# **Awel y Môr Offshore Wind Farm**

## **Applicant's Response to the Examining Authority's Third Written Questions**

### **Deadline 7**

**Date: 08 March 2023**

# Appendix C: Response to ExQ3.9.8, Revised Plan showing Agricultural Land Classification (Wales) Surveys and results of 2023 ALC Survey at Faenol Bropor

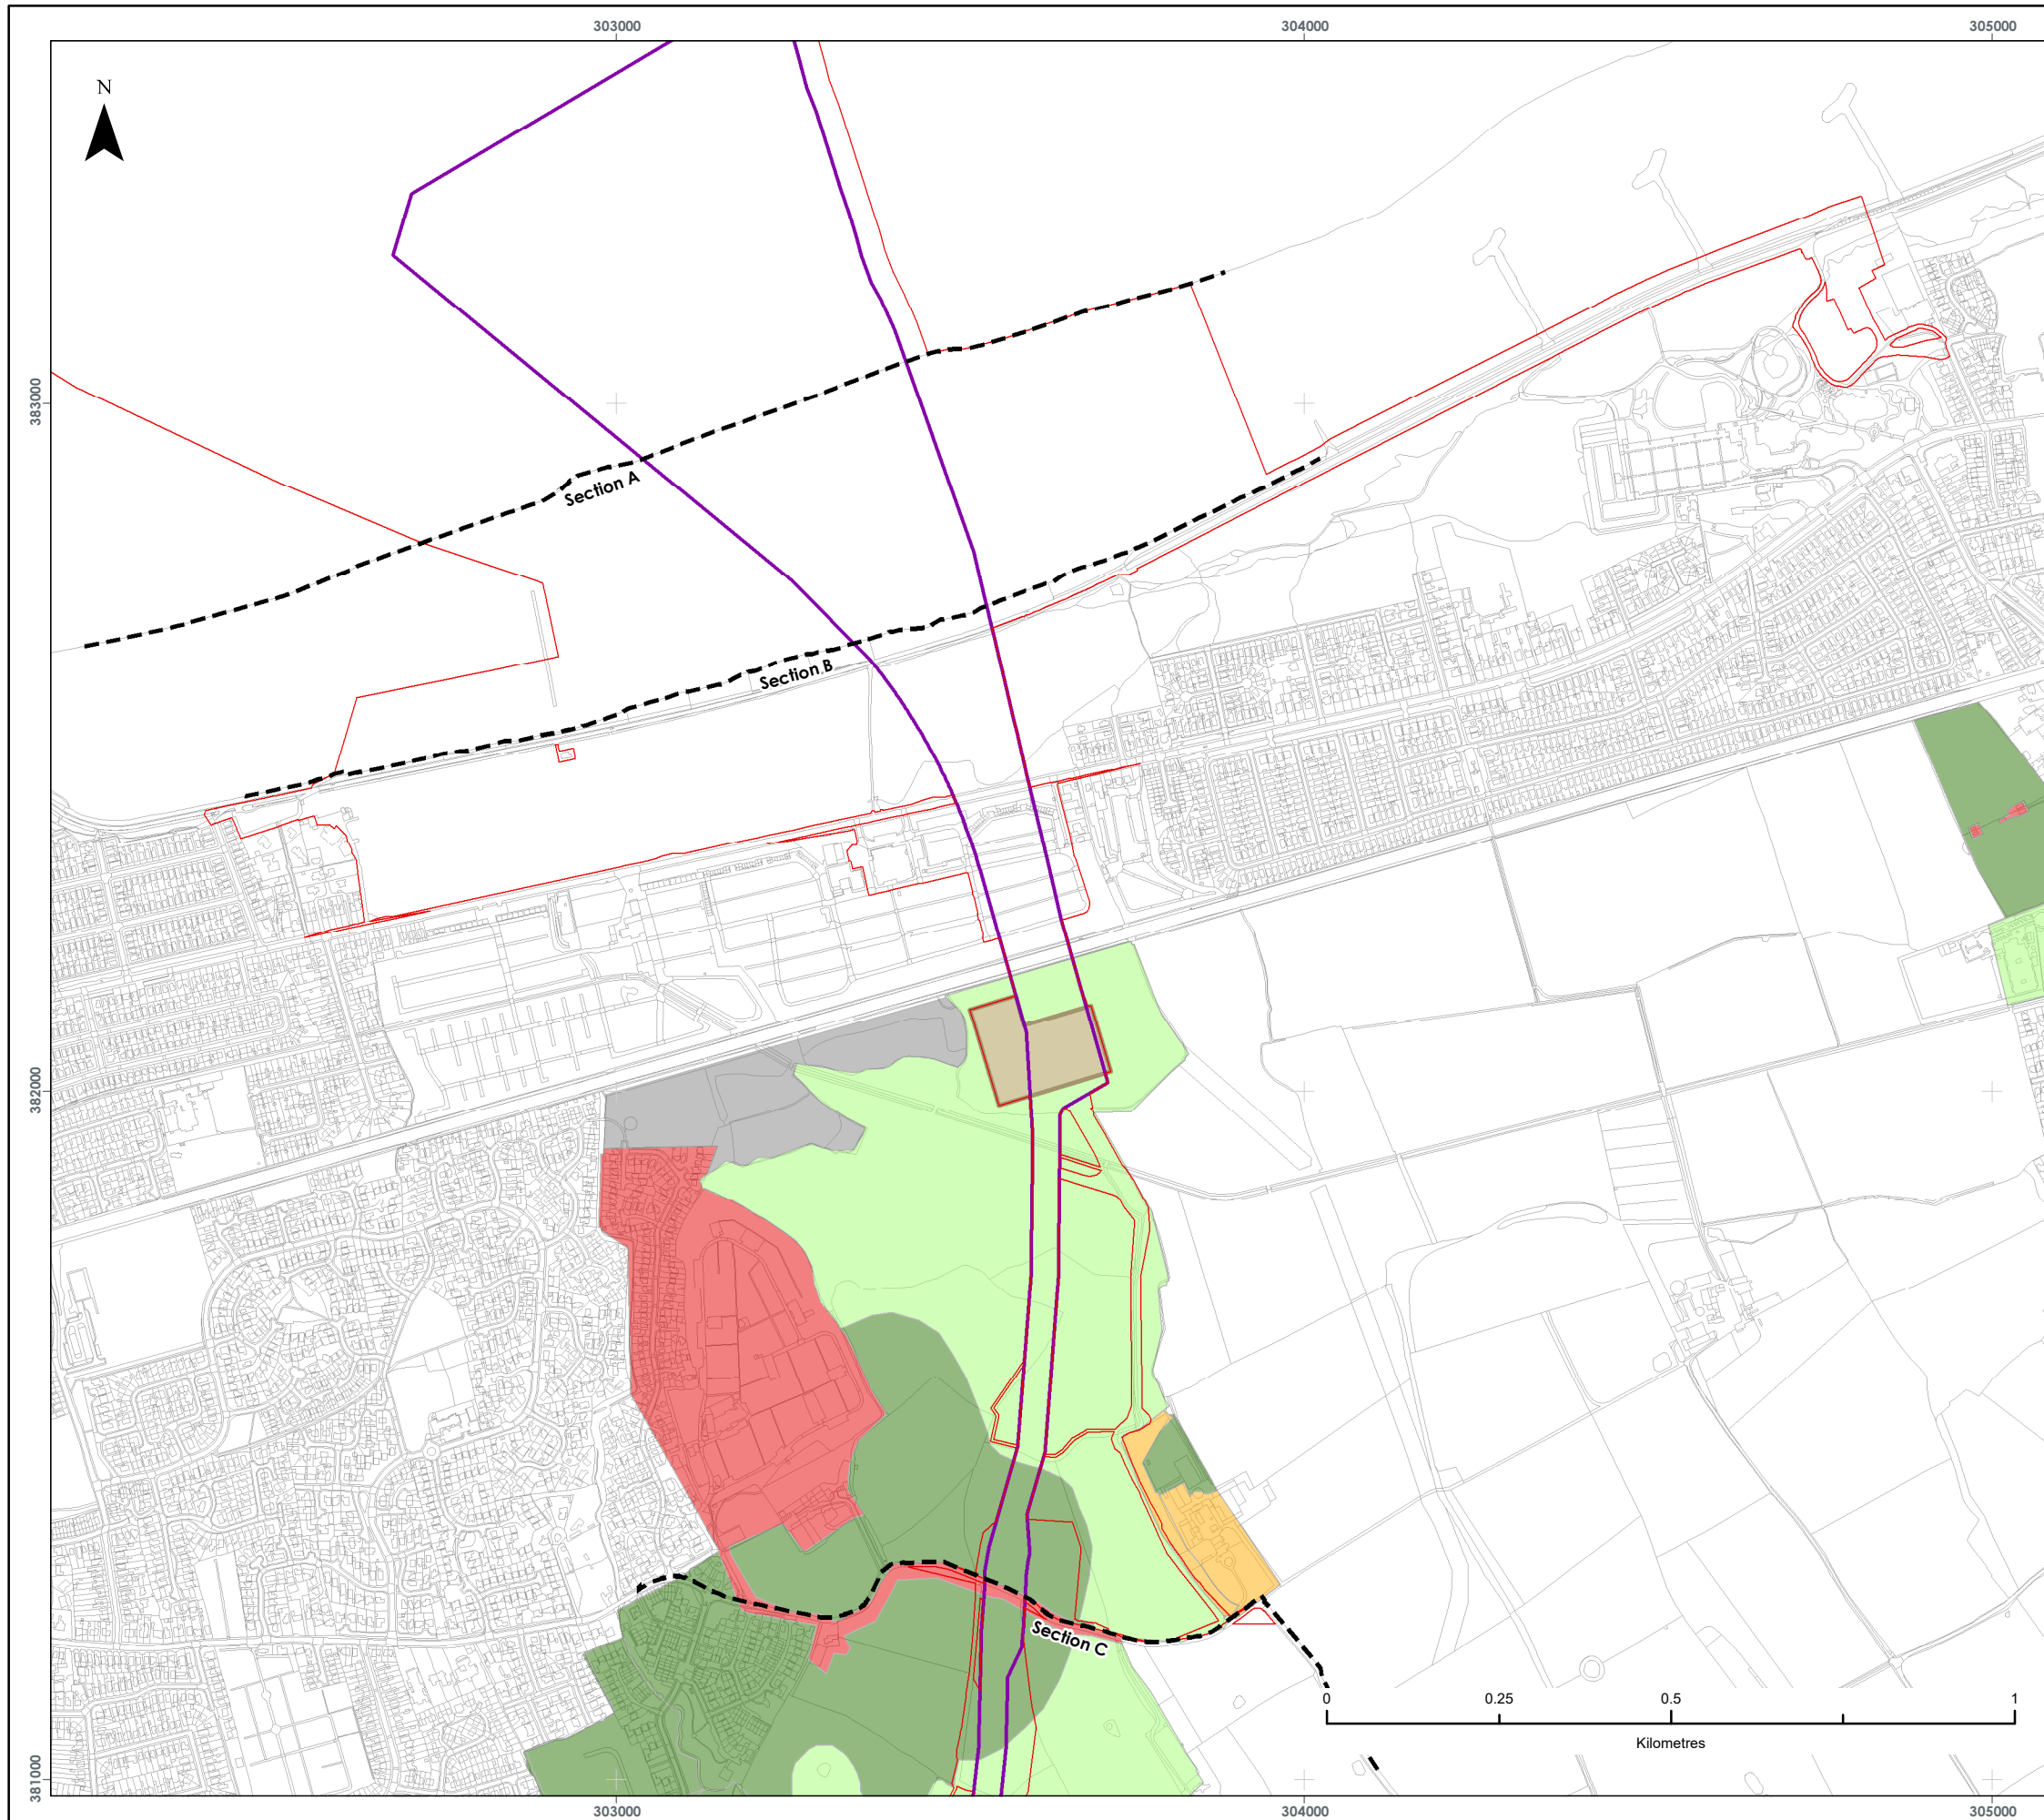
QUESTION NUMBER	QUESTION ADDRESSED TO	QUESTION	APPLICANT'S RESPONSE																											
	Farming Company																													
9.6	Applicant	<p><b>Onshore Substation Site (OnSS)</b></p> <p>Noting that a further Agricultural Land Classification (ALC) survey has been undertaken at the proposed OnSS site, is it necessary to update the table provided in response to ExQ1.9.8 [REP1- 007]?</p>	<p>The Applicant has updated the table to incorporate the results of the 2023 Agricultural Land Classification (ALC) survey as follows:</p> <p>The area of the OnSS footprint and wider landscape mitigation and ecological compensation and enhancement area (Plot 417), includes 1.5 Ha of Grade 3a which represents 0.69% of Grade 3a within 1000m of OnSS and 0.011% of Grade 3a land in Denbighshire.</p>
